## DRAINAGE AND TRANSPORTATION INFORMATION SHEET

**RE: 2350 ALAMO ROAD SW  
TRAFFIC CIRCULATION LAYOUT  
RESPONSE TO COMMENT**

ENGINEER'S SEAL	2350 ALAMO AVE SE ALBUQUERQUE, NM	DRAWN BY RMG
	TRAFFIC CIRCULATION LAYOUT	DATE 05-08-2023
	 <div>TERRA WEST, LLC 5571 MIDWAY PARK PL NE ALBUQUERQUE, NEW MEXICO 87109 (505) 858-3100 www.tierrawestllc.com</div>	DRAWING 2021108-F1
		SHEET # TCL-1
06/27/2023  RONALD R. BOHANNAN P.E. #7868		JOB # 2021108

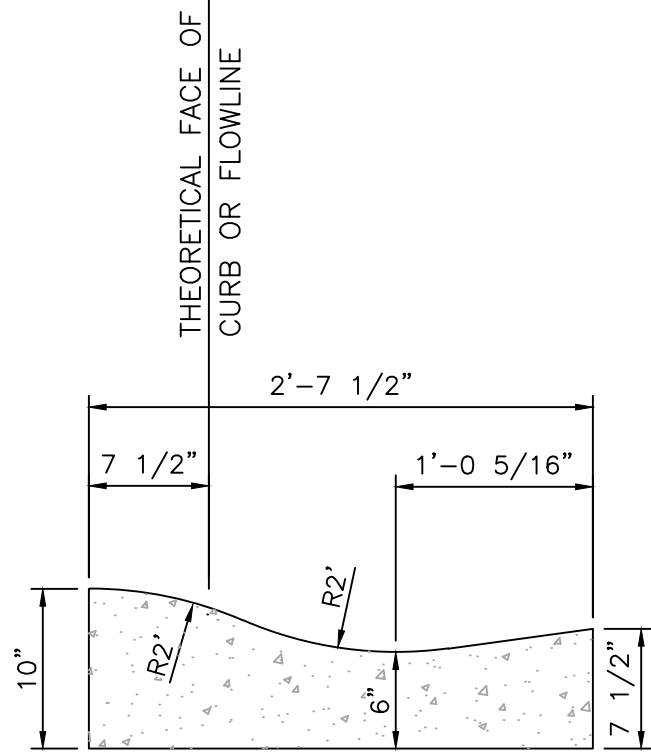
4. Please show on the site plan the distance between both site accesses.

15. Curbing should be installed to delineate landscape, parking, and pedestrian ways and identify points of access. Please call out detail and location of barrier curb.

16. Parking areas shall have barriers to prevent vehicles from extending over public sidewalk, public right-of-way, or abutting lots.

19. Please show on the site plan the clear sight distance triangle exhibit.

20. Please specify the City Standard Drawing Number when applicable.

22. Please add a note on the plan stating "All improvements located in the Right of Way must be included on the work order."

**Response: See updated traffic circulation plan.**

**Response: See updated traffic circulation plan.**

**Response: See updated traffic circulation plan.**

**Response: See updated traffic circulation plan.**

**Response: See updated traffic circulation plan.**

**Response: Note added to traffic circulation plan.**

**HC PARKING DETAIL**

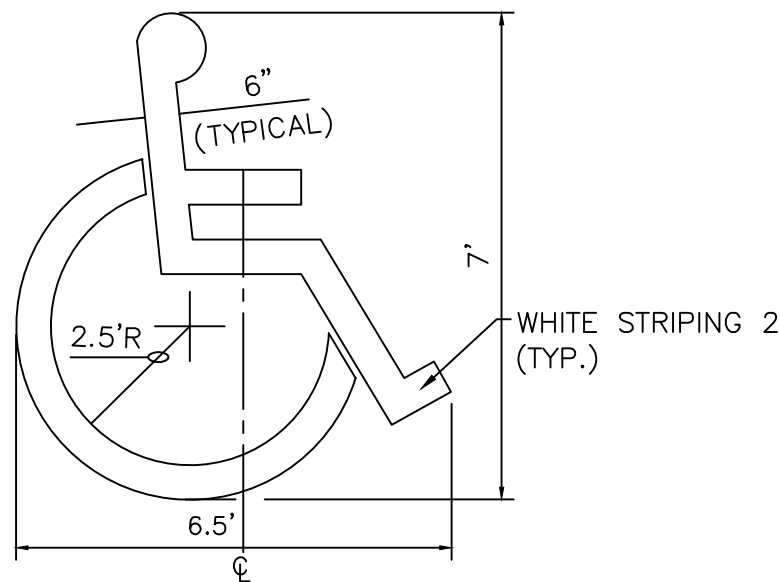
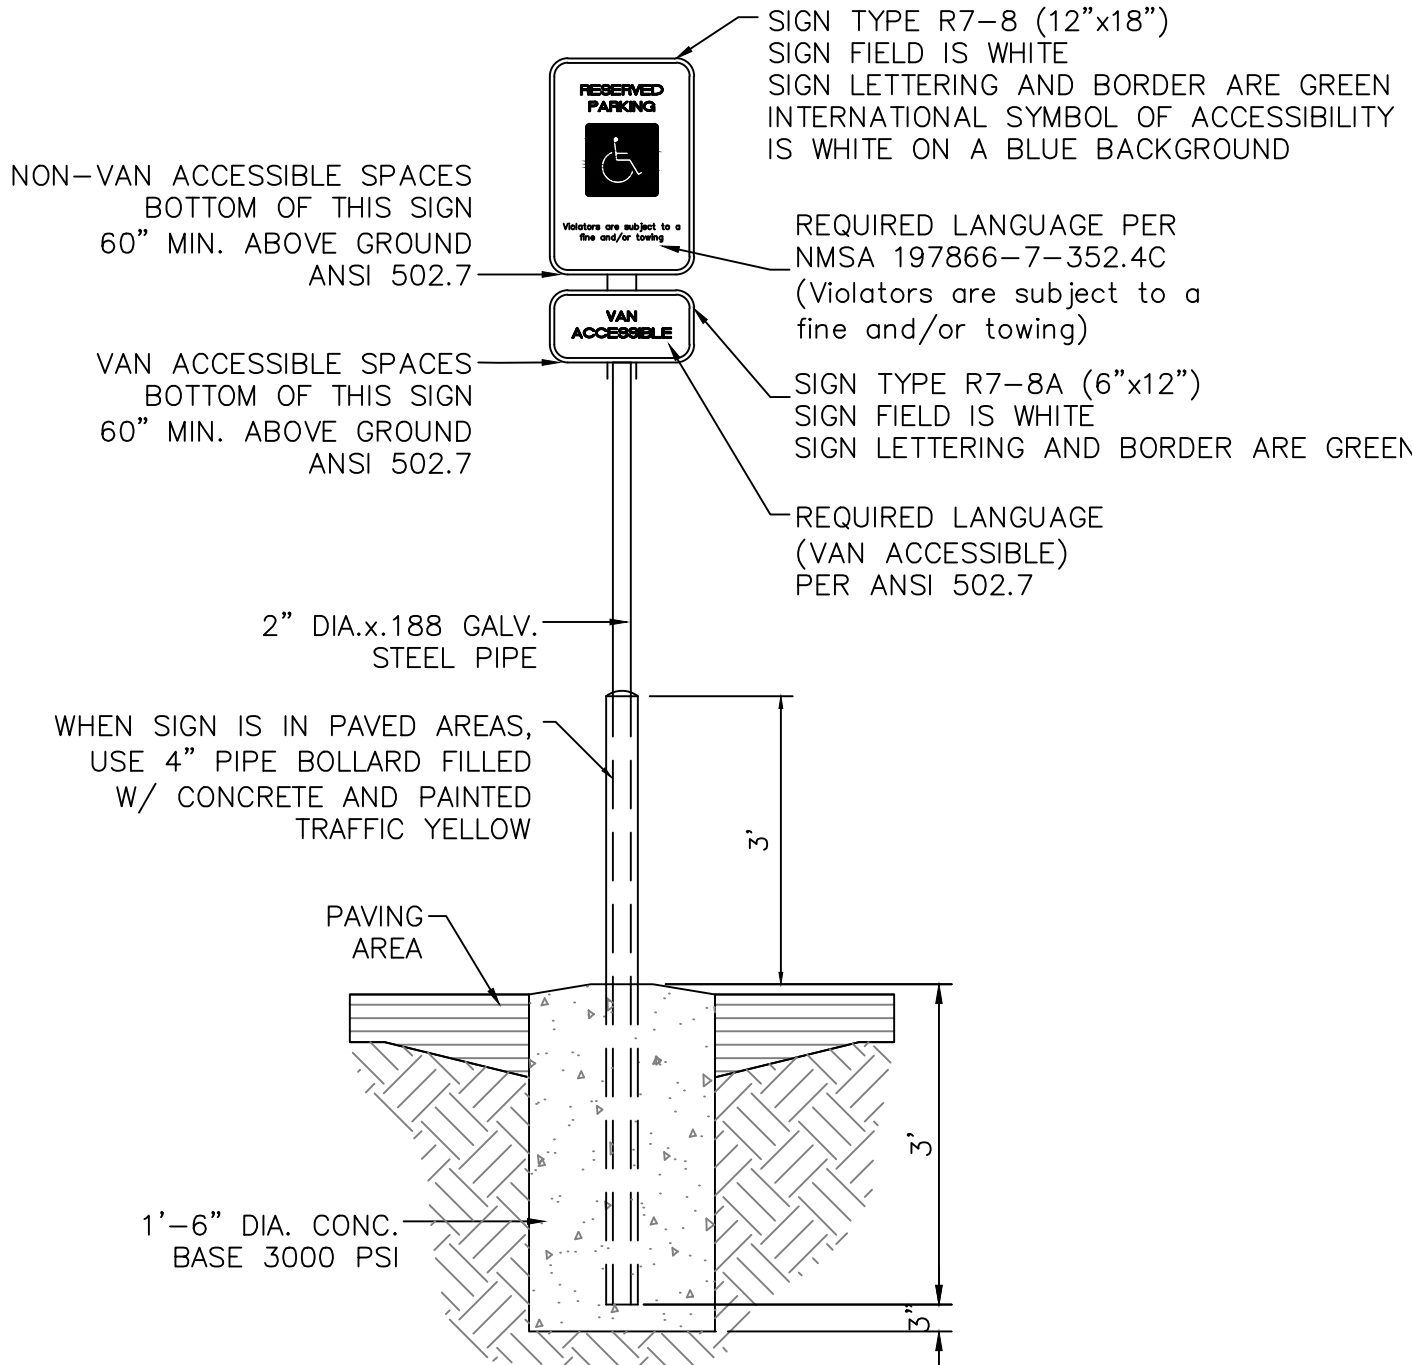
8. The ADA accessible parking sign must have the required language per 66-7-352.4C NMSA 1978 **"Violators Are Subject to a Fine and/or Towing."** Please call out detail and location of signs.

9. The ADA access aisles shall have the words **"NO PARKING"** in capital letters, each of which shall be at least one foot high and at least two inches wide, placed at the rear of the parking space so as to be close to where an adjacent vehicle's rear tire would be placed. (66-1-4.1.B NMSA 1978)

**Response: See detail sheet C2.1.**

**Response: See detail sheet C2.1.**

BIKE RACK  
SCALE: NONE

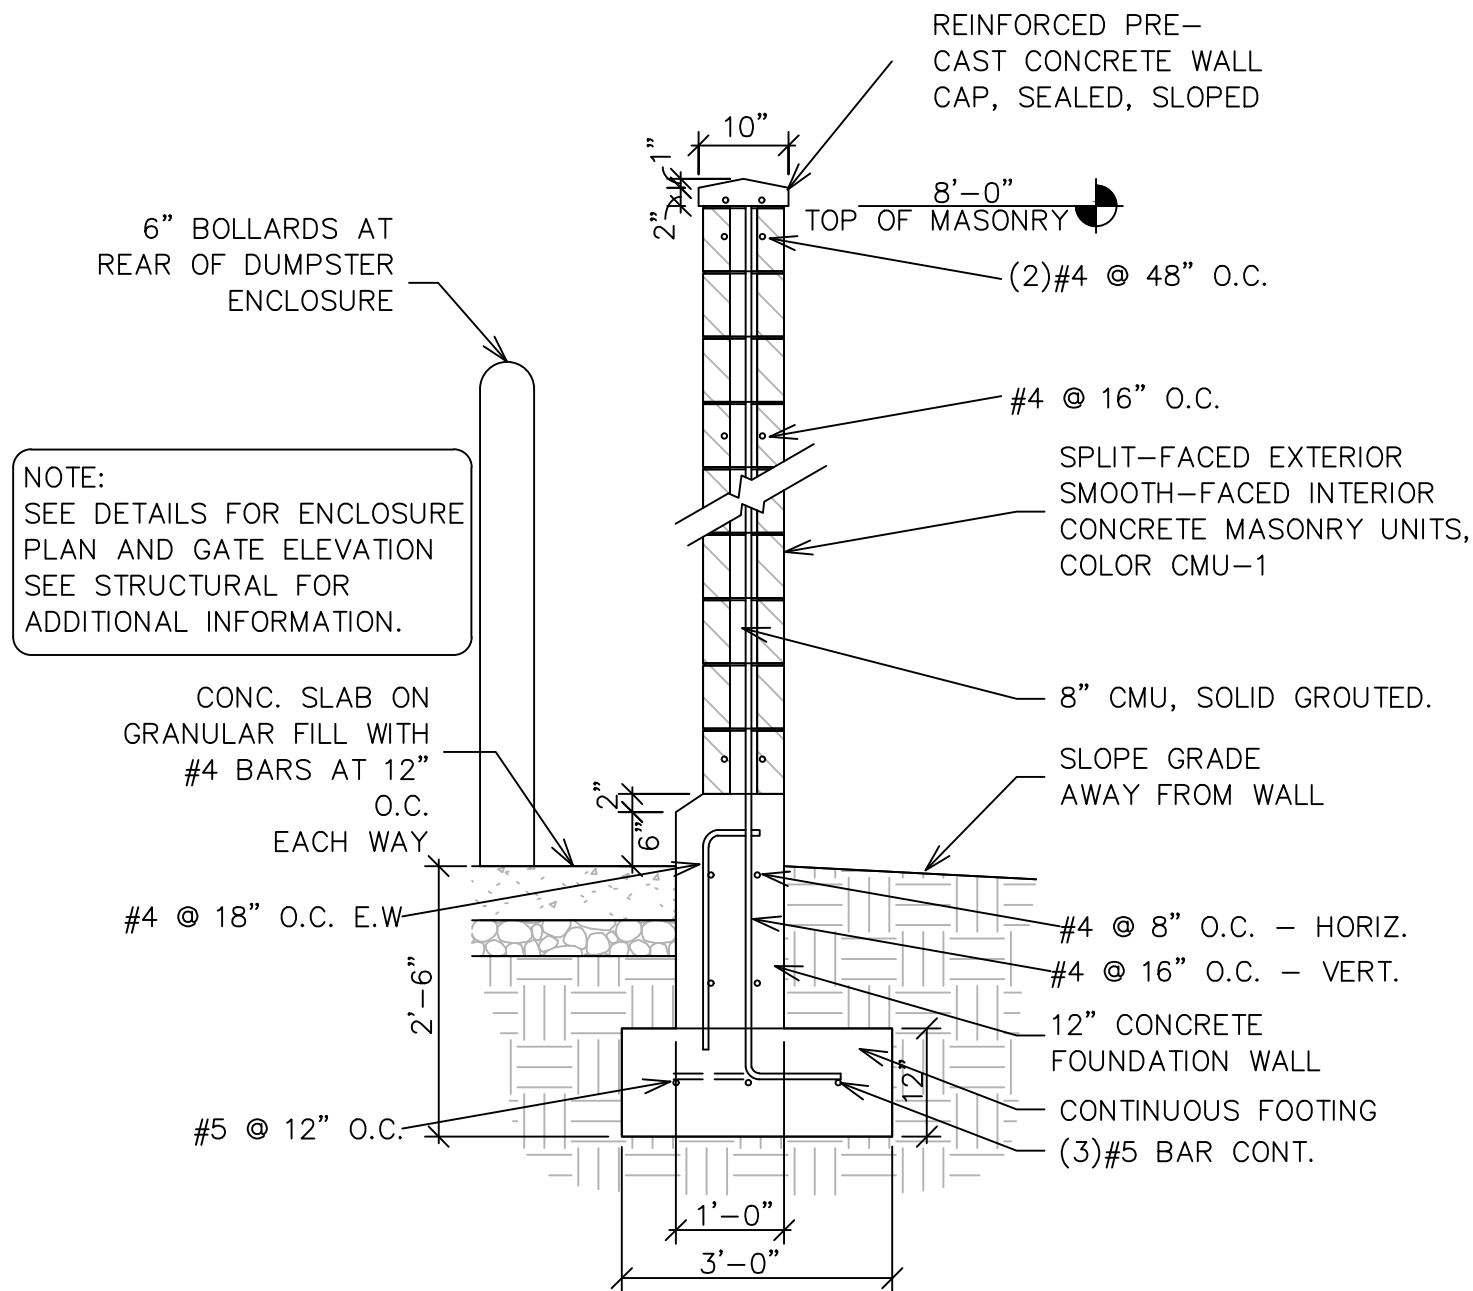
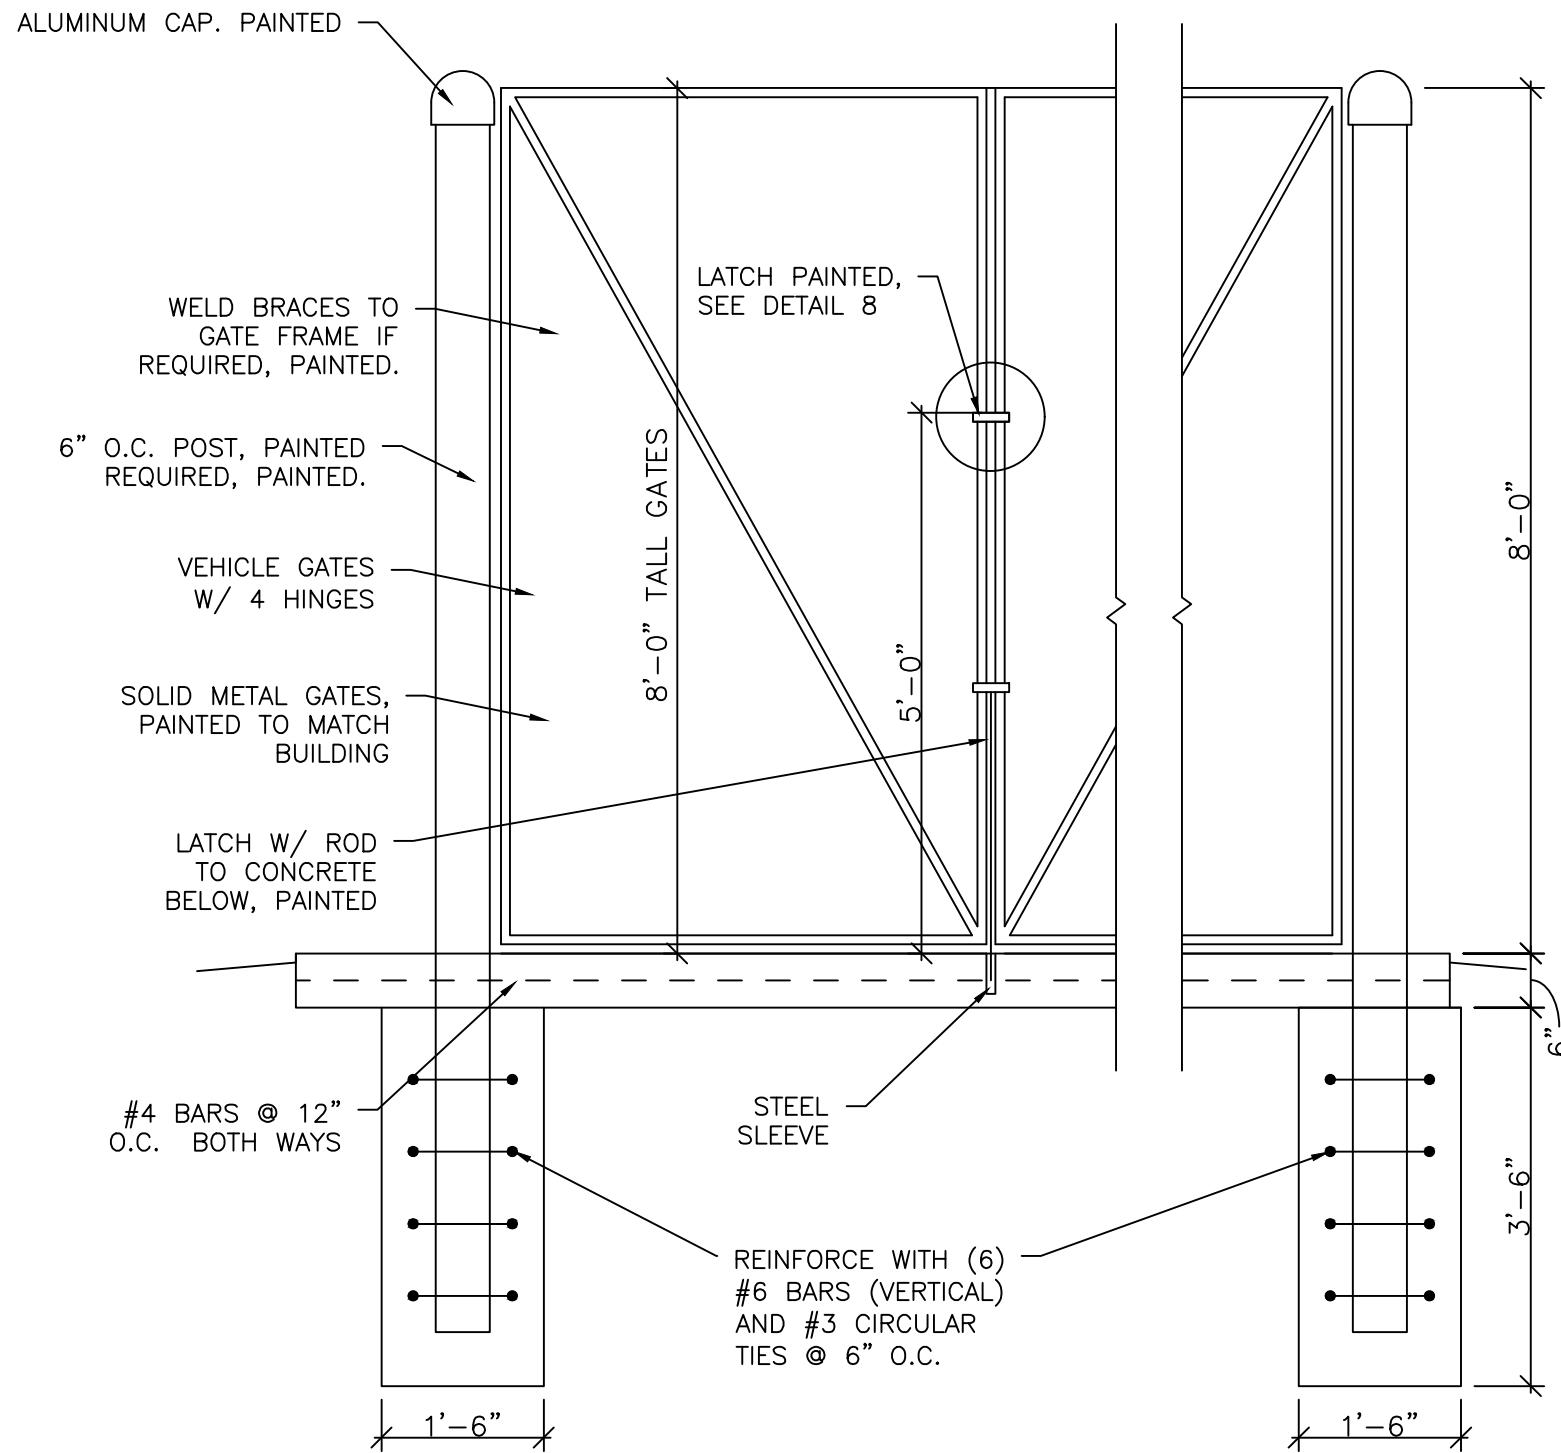
10. Please provide Bike Rack details.

11. All bicycle racks shall be designed according to the following guidelines:

- a. The rack shall be a minimum 30 inches tall and 18 inches wide.
- b. The bicycle frame shall be supported horizontally at two or more places. Comb/toaster racks are not allowed.
- c. The rack shall be designed to support the bicycle in an upright position. See the IDO for additional information.
- d. The rack allows varying bicycle frame sizes and styles to be attached.
- e. The user is not required to lift the bicycle onto the bicycle rack.
- f. Each bicycle parking space is accessible without moving another bicycle.

12. Bicycle racks shall be sturdy and anchored to a concrete pad.

13. A 1-foot clear zone around the bicycle parking stall shall be provided.

14. Bicycle parking spaces shall be at least 6 feet long and 2 feet wide.

**Response: See detail sheet C2.2.**

**Response: See detail sheet C2.2.**

**Response: See detail sheet C2.2.**

**Response: See detail sheet C2.2.**

**Response: See detail sheet C2.2.**
